**Final Supplement
to the
final
environmental
statement**

**THREE MILE ISLAND
NUCLEAR STATION, UNIT 2**

DECEMBER 1976

Docket No. 50-320

Fig. 6.2 Locations of trapnet and seine stations in the vicinity of TMINS.

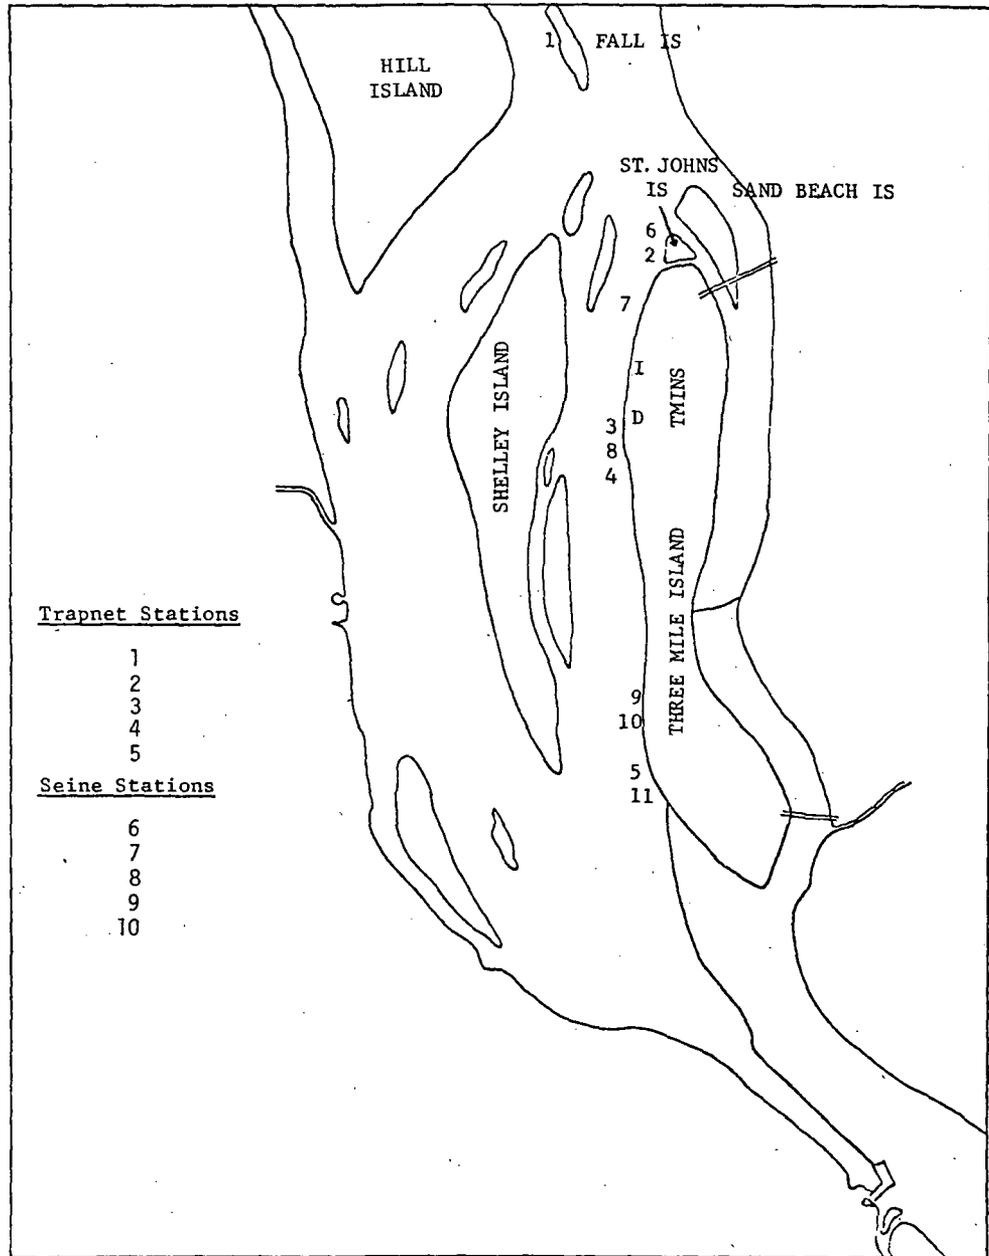
In Figure 6.2, station number 11 should be listed under Seine Stations. The figure represents sampling locations only applicable to 1974. The figure title, therefore, should be changed to read: "Trapnet and Seine Stations Sampled in the Vicinity of TMINS during 1974".

Fig. 8.2 - Total Generating Cost \$/kW/Year as a Function of Plant Capacity Factor

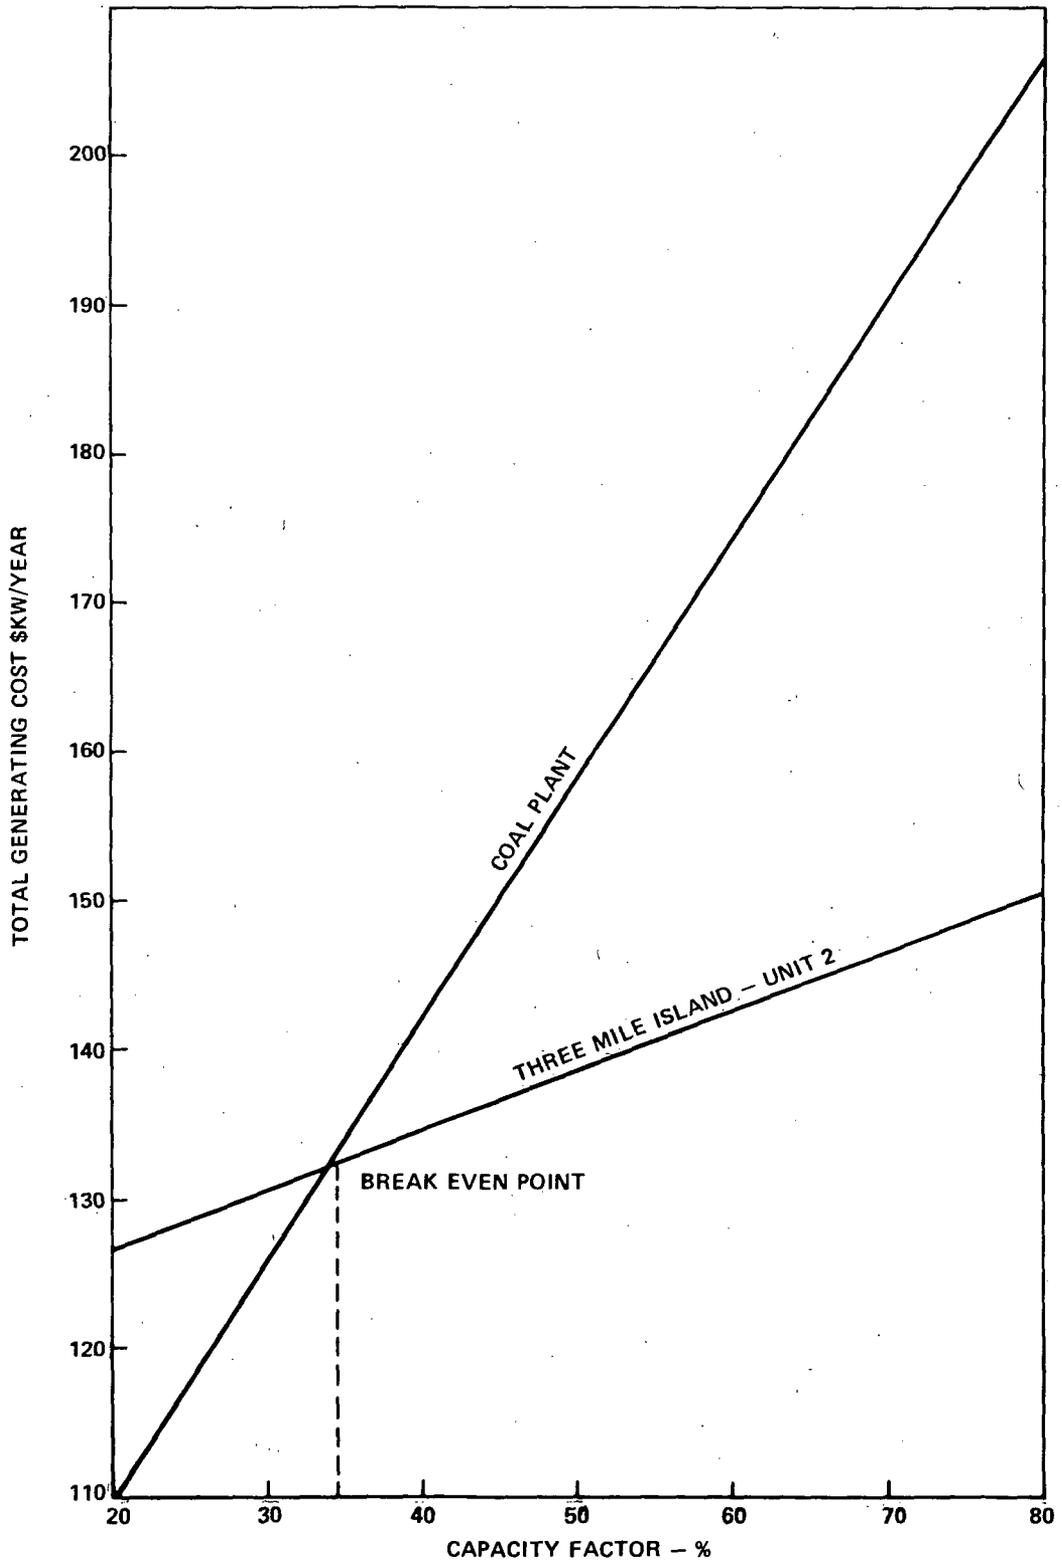
The almost ridiculous lengths the NRC staff will go to to cover and protect its bungling industry is exemplified in Table 8.2 and Figure 8.2. The costs for the plant are all given in dollars for each installed kilowatt for a year's operation. But an installed kilowatt produces something unless the plant operates, and the data from the table plotted in the figure suggests that the cheapest operating costs for the coal and nuclear power plants are obtained when both are inoperable. The NRC has seemingly forgotten that ~~costs~~ some vary with the production from the plants. For a nuclear plant, the biggest variable cost is the investment cost, and it cannot be treated as a fixed production cost, as is shown in the table and figure. For a coal plant the biggest variable cost is fuel, as is properly shown. When the investment costs are treated as they should for both plants, as cost per unit of electrical production, or cents per kilowatt-hour, a very different picture emerges. On the table below are listed, for the coal and nuclear plants, the same of the data from Table 8.2, adjusted to represent electricity generation costs in cents per kilowatt-hour. Only corrected numbers are given. The only correction is made by multiplying back to the "investment cost" and the "Total Operating Cost" by $\frac{100,000}{5,000,000}$ except for the "investment cost" and by the same factor without the capacity factor for the "Total Operating Cost." The capacity factor is left out of the latter factor since it is already included in the table.

Figure 10 - VENTILATION SYSTEM, THREE MILE ISLAND NUCLEAR STATION - UNIT 2

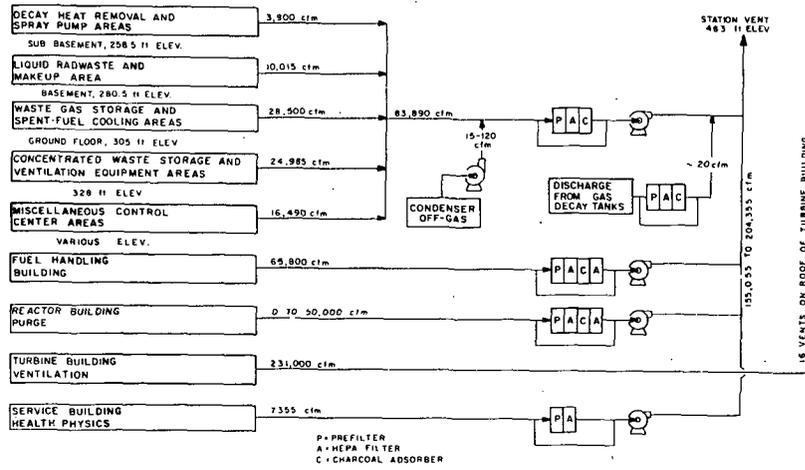
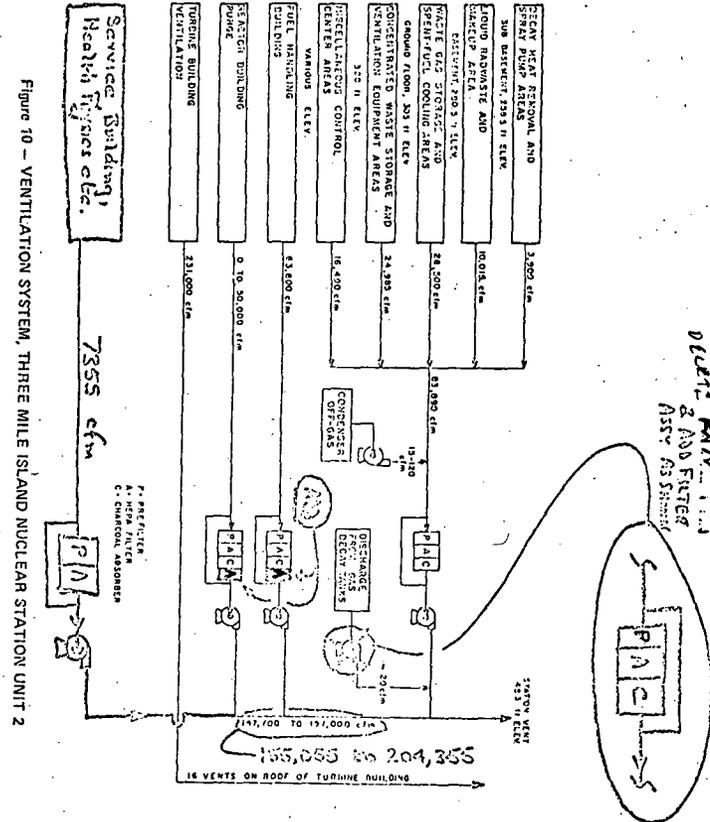
- Figure 10, Ventilation System, Three Mile Island Nuclear Station Unit 2, on Page III-11 should be revised as shown on the attached sketch.
- Figure 12, Liquid Radioactive Waste Treatment System, Three Mile Island Units 1 and 2, on Page III-14 should be revised to indicate the capability to direct the Powdex sluice water and the deep bed resins and effluent to the radwaste system as shown on the attached sketch.
